# PUYALLUP 2ND STREET APARTMENTS

Project Title:  
**PUYALLUP 2ND STREET APARTMENTS**

Issue Set & Date:  
**SITE DEVELOPMENT PERMIT SET**  
2/7/2024

## HORIZONTAL CONTROL AND SURFACING PLAN

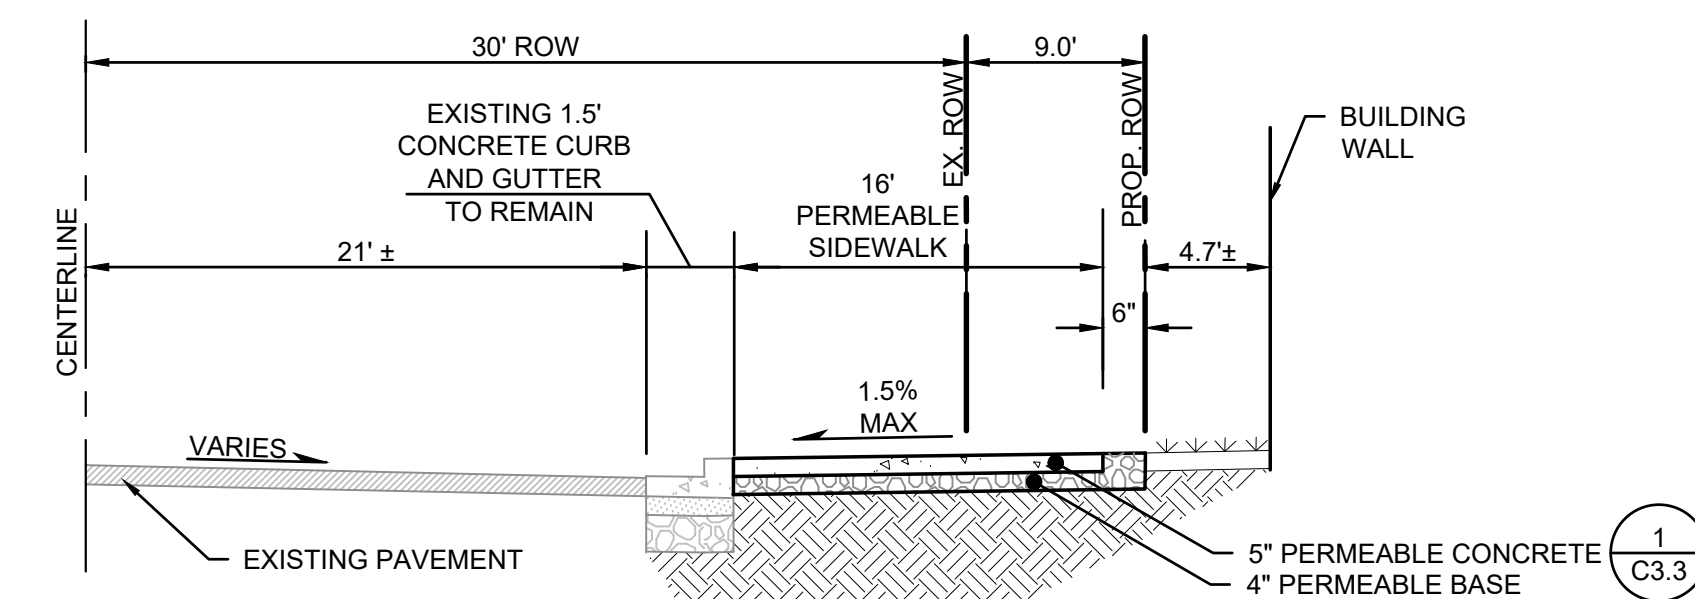
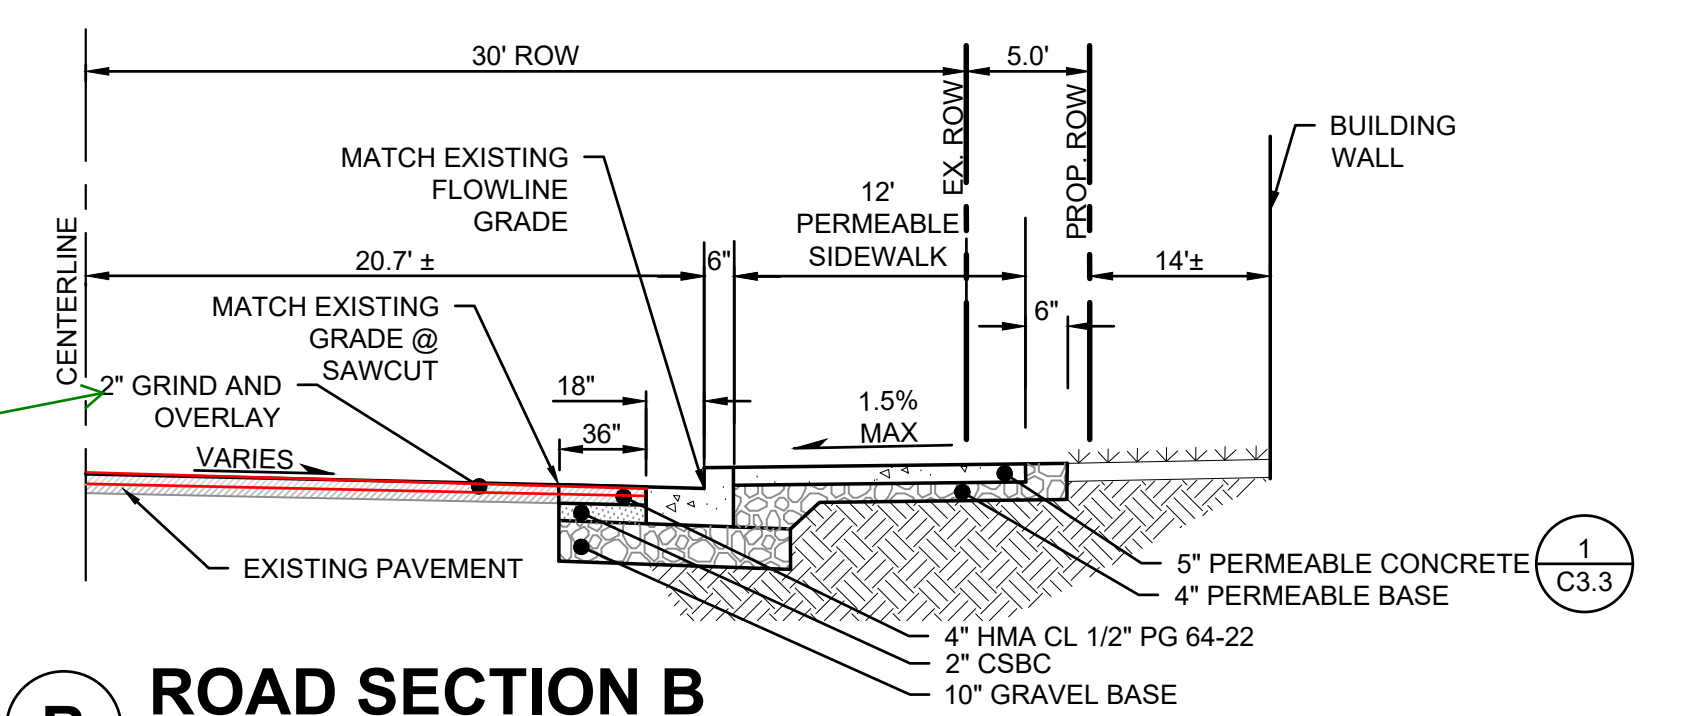
with this very wide sidewalk why is there one bench right next to the curb, should be moved, this impedes pedestrian flow, shows more in the middle in the landscape plans C.2.0 SH

WSDOT Field guide states when pedestrian path crosses a curb ramp from the side a flared side is needed C.2.0 SH. WSDOT examples show a non walking surface or buffer

driveway should be dense concrete, this appears to show the ramps dense but not the driving surface C.2.0 SH

remove C curb C.2.0 SH  
C curb to remain

Benched moved, refer to updated landscape plans C.2.0 SH

Hatching changed to show dense concrete along driveway

## GRADING AND DRAINAGE PLAN

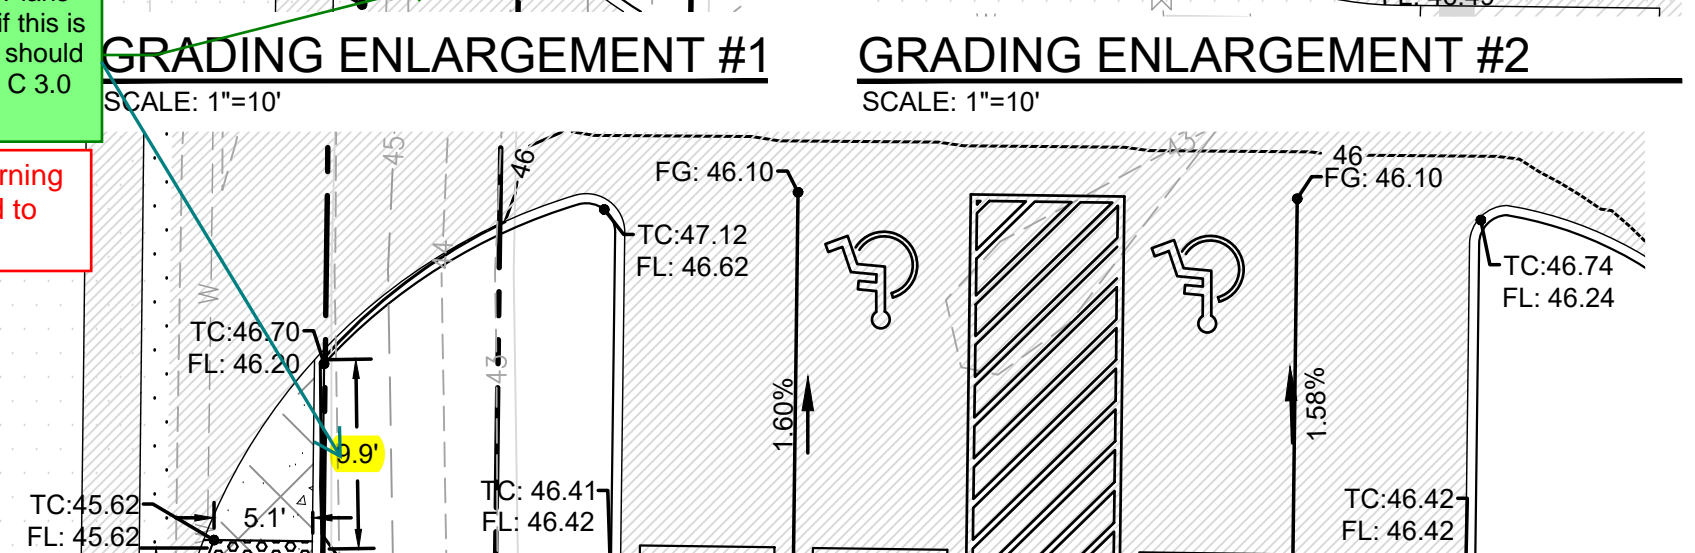
Clarify intent of infiltration/gravel ditch. Is this just for the run off from the slope east of the curbing? [CIVIL PLANS, Sheet C3.0]

If new driveway approach places CB outside of stormwater gutter collection path, relocate as needed. [CIVIL PLANS, C3.0]

Provide legend this sheet or label previous concrete areas on Grading and Drainage Plan. [CIVIL PLANS, Sheet C3.0]

CB currently has a horizontal grate. Update lid and frame if needed to current standard. [CIVIL PLANS, C3.0]

From this point, it is the preference of the collections division that the 12 inch stormwater piping be relocated to the right of way and discharged, continuing west to 2nd St NE, to a new structure. The ability to repair, replace or maintain the existing stormwater system in its current location would be greatly impacted with the proposed building structure so close. The then abandoned, existing pipes and manhole should be removed. [CIVIL PLANS, C3.0]

Note added to clarify infiltration ditch only for run off from the slope

Legend provided for concrete areas

Note added to update CB lid and frame
